APPLICATION FOR PERMIT TO DRILL, RE-ENTER, DEEPEN, PLUGBACK, OR ADD A ZONE

1. Operator Name and Address CHEVRON U S A INC 11111 S. WILCREST HOUSTON , TX 77099		2. OGRID Number 4323
		3. API Number 30-025-38849
4. Property Code 29923	5. Property Name CENTRAL VACUUM UNIT	6. Well No. 238

WELL LOCATION AND ACREAGE DEDICATION PLAT

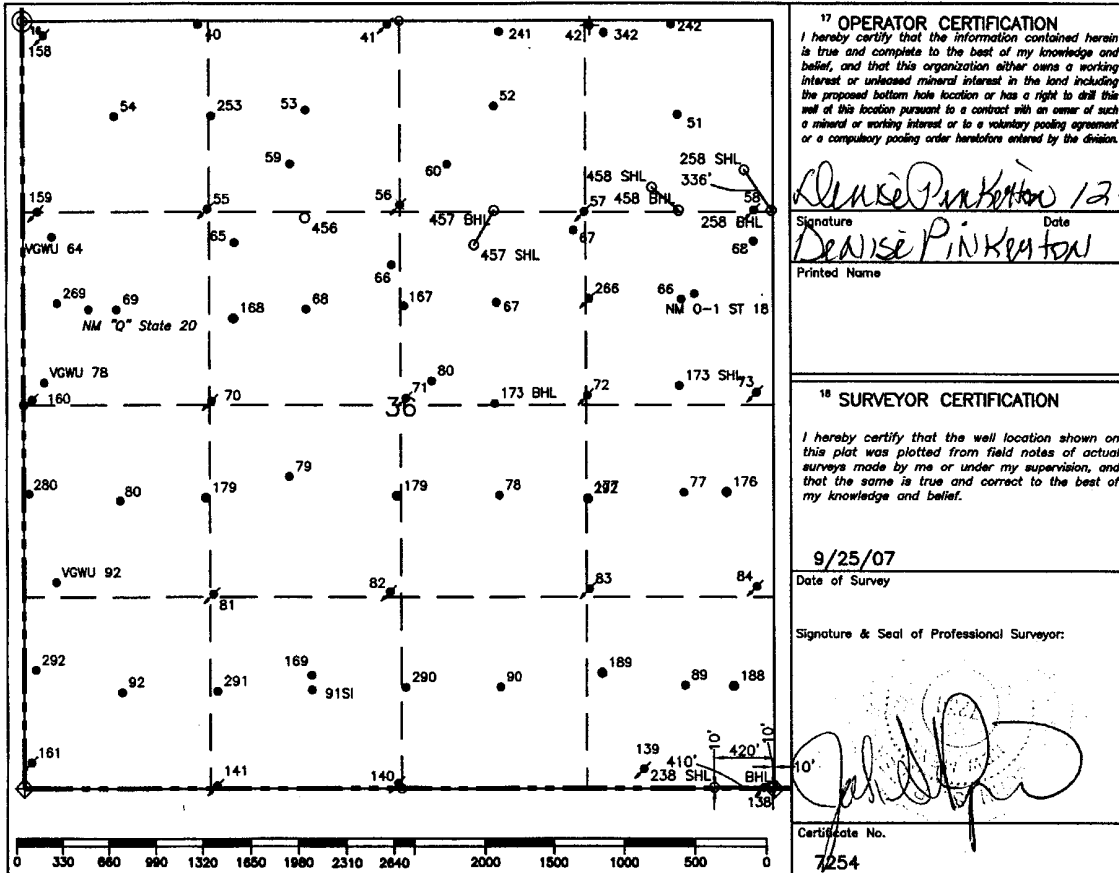
Created By	Comment	Comment Date
DMULL	Holding for Non-Standard Location approval.	12/12/2007
DMULL	NSL-5789-A, 04/02/08, SUR: 10/S & 420/E, BHL: 10/S & 10/E, Vacuum Grayburg-San Andres.	4/14/2008

OCD Reviewer	Condition
DMULL	Will require administrative order for non-standard location
pkautz	Pit construction and closure must satisfy all requirements of your approved plan, O.C.D. Rule 19.15.2.50, and the Pit and Below-Grade Tank Guidelines
DMULL	NSL-5789-A, 04/02/08, SUR: 10/S & 420/E, BHL: 10/S & 10/E, Vacuum Grayburg-San Andres.
